<b>MODEL</b>	F20 Sorter	<b>VOLT/Hz</b>	<b>DATE OF MODIFICATION</b>	<b>SERIAL NO.</b>
<b>MODIFIED ARTICLE</b>	Parts Catalog			
<b>REASON OF MODIFICATION</b>

Please correct your parts catalog as follows:

**2. TRANSPORT 1 (Page 3-6)**

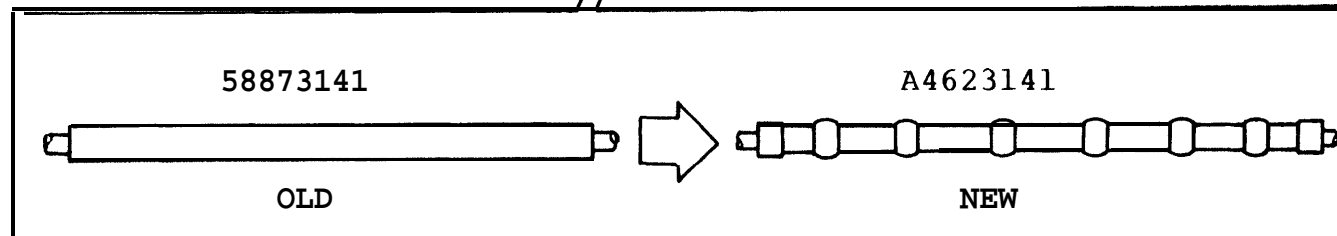
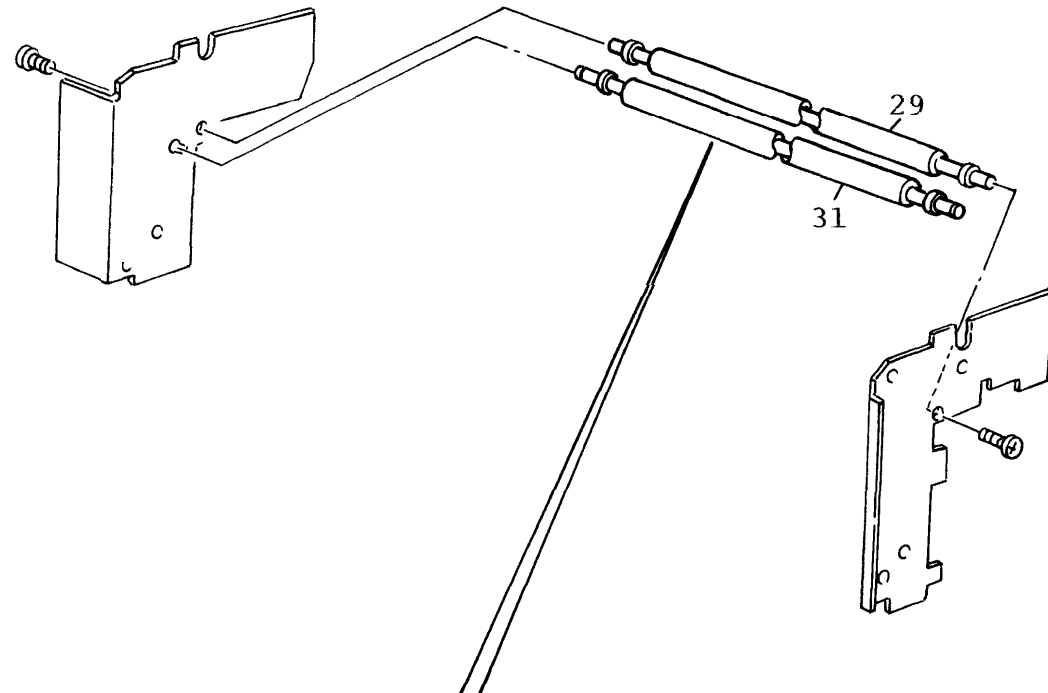
To prevent the transport belts from moving out of their correct positions on the transport rollers, one of the transport belt rollers has been changed to the rounded type as shown in the illustration. As a result, when the transport belts start meandering, the new roller returns them to their correct positions.
